TOWN OF
BRECKENRIDGE

Planning Commission Meeting Agenda

Tuesday, December 3, 2019, 5:30 PM

Planning Commission Staff Report

ENLARGED STAIR #1
 1/4" = 1'
 NORTH

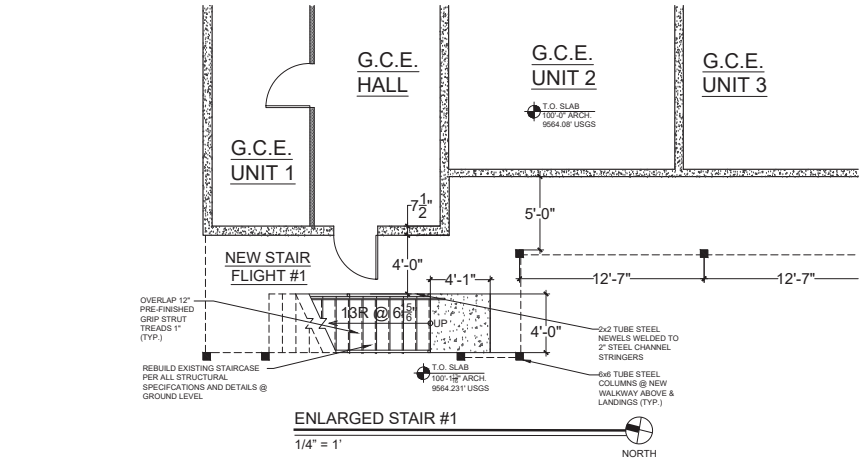
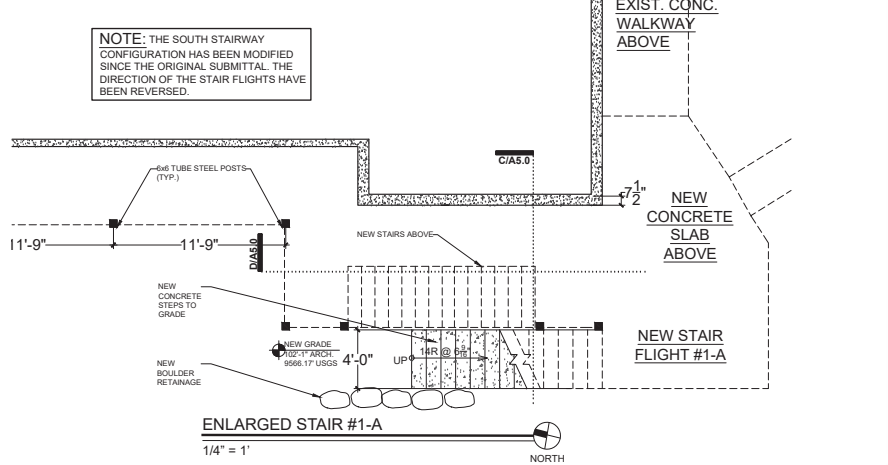
NOTE: THE SOUTH STAIRWAY CONFIGURATION HAS BEEN MODIFIED SINCE THE ORIGINAL SUBMITTAL, THE DIRECTION OF THE STAIR FLIGHTS HAVE BEEN REVERSED.

ENLARGED STAIR #4

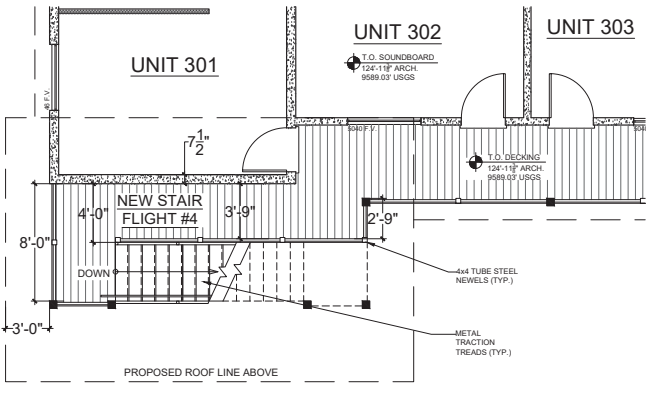
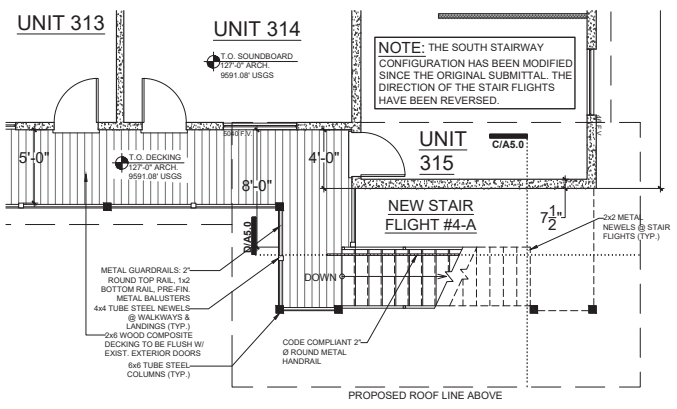
NOTE: THE SOUTH STAIRWAY CONFIGURATION HAS BEEN MODIFIED SINCE THE ORIGINAL SUBMITTAL. THE DIRECTION OF THE STAIR FLIGHTS HAVE BEEN REVERSED.

SHEET TITLE:
 NORTH ELEVATION

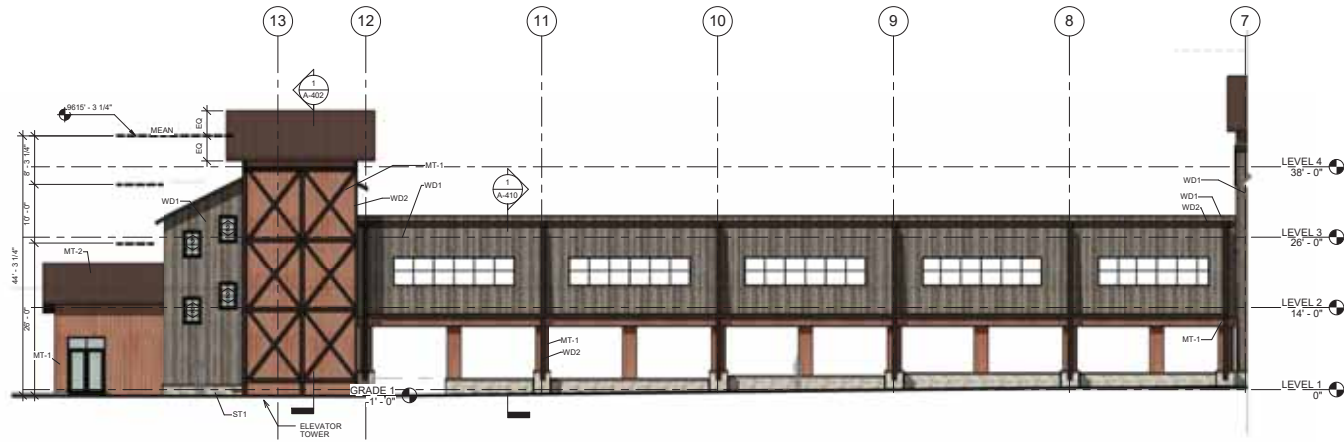
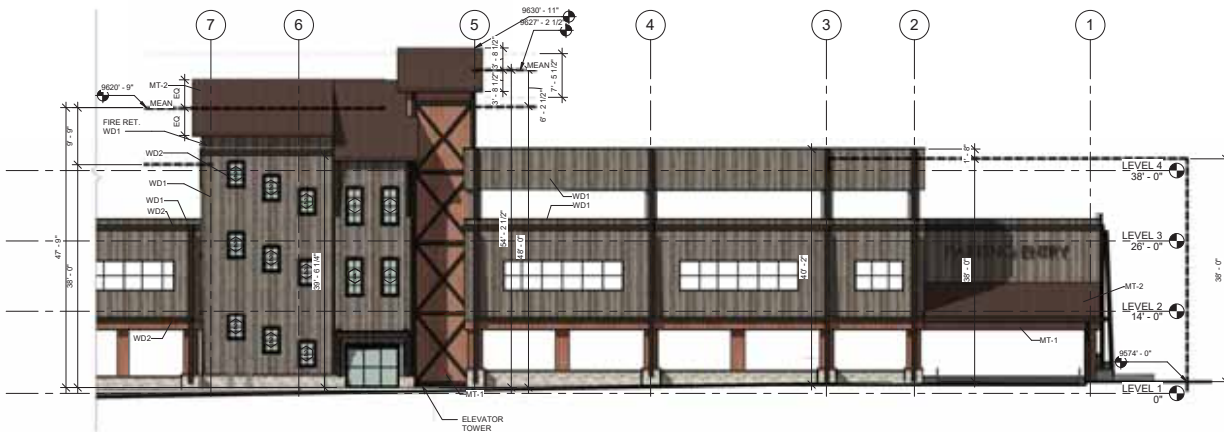
The height of the tallest measured portion of the structure is 48’-9” to the mean roof height of the middle, northern façade’s stair tower, best illustrated on sheet A-302 as measured from the mean to the finished grade below. This exceeds the building height recommended in the land use guidelines by more than one-half (1/2) story but less than one story. At the worksession, the Commission advised that since the elevation is past the mid-point of the lot and thus setback from the Historic District, the recommended height is three stories. Based on this direction, staff has awarded negative ten (-10) points under Policy 6/R.
